Addendum #5

Bennett's Creek Health & Rehabilitation Center 1931 / 1975 Bridge Road Suffolk, VA 23434

DSCA Project No. 24.061

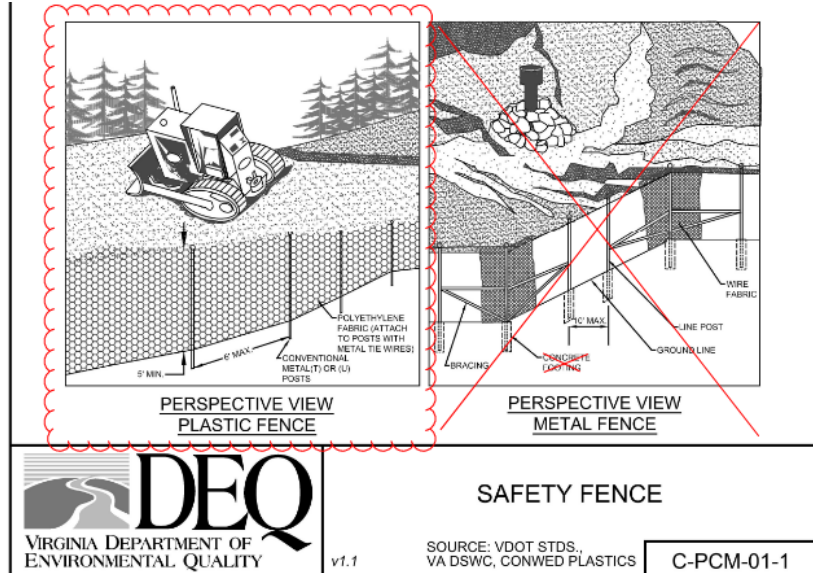
Landscape / Mulch / Soil / Sod

- Please provide/clarify the mulch and soil specifications for the project. **RESPONSE:** MULCH SPECIFICATION IS CALLED OUT ON PLANS AS DOUBLE SHREDDED HARDWOOD BARK MULCH. SOIL SPECIFICATION IS VDOT SECTION 602. QUANTITY CALLED OUT ON LANDSCAPE PLAN ATTACHED.

- We have reviewed the bid package and have not located notes identifying the mulch and soil quantities required. We also noticed that some bed edging appears to be missing. Please provide the required quantities and/or additional details necessary to prepare an accurate estimate. **RESPONSE:** PLEASE REFER TO UPDATED LANDSCAPE PLAN ATTACHED.

- Please confirm whether sod is included in the project scope and, if so, provide the applicable specifications and quantities. **RESPONSE:** SODDING IS CALLED OUT FOR THE BOTTOM OF GRASS SWALE IN THE ROADWAY MEDIAN.

- Additional clarification of the limits and quantities of the landscape beds would also be helpful so that the required sod quantities can be accurately estimated. **RESPONSE:** LAWN LIMITS ARE SHOWN IN HATCH PATTERN.

RESPONSE: THE FOLLOWING SUPERCEDES ALL RFIs REGARDING MULCH & SOIL ADDRESSED IN ADDENDUM #4 SEE REVISED DRAWINGS LP-101, LP-102 AND LP-501. DRAWINGS LS-101 AND LS-102 REPLACE L1.1 & L1.2 IN THE CIVIL SET.
